Service Bulletin

Subject: Noise, Vibration, Moaning Sounds and/or Rattle Heard at Idle or While Driving

Models: 2014-2016 Cadillac ELR
2011-2015 Chevrolet Volt

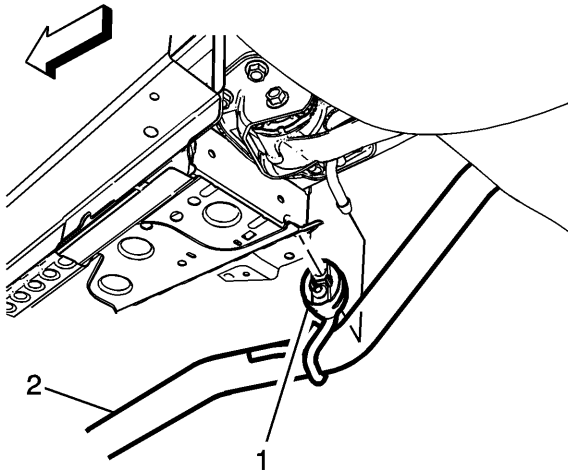
2. Loosen the exhaust muffler clamp (1) from the catalytic converter (2).

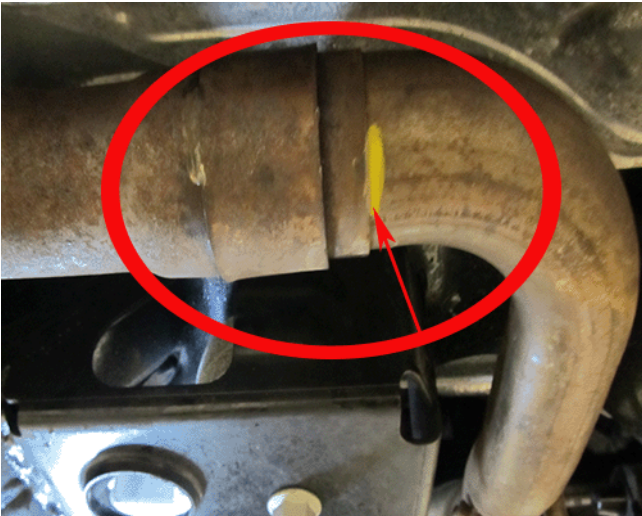
3. Remove the exhaust pipe from the exhaust isolator (1).
4. Disconnect the heated oxygen sensor. Refer to Heated Oxygen Sensor Replacement - Sensor 2 in SI.
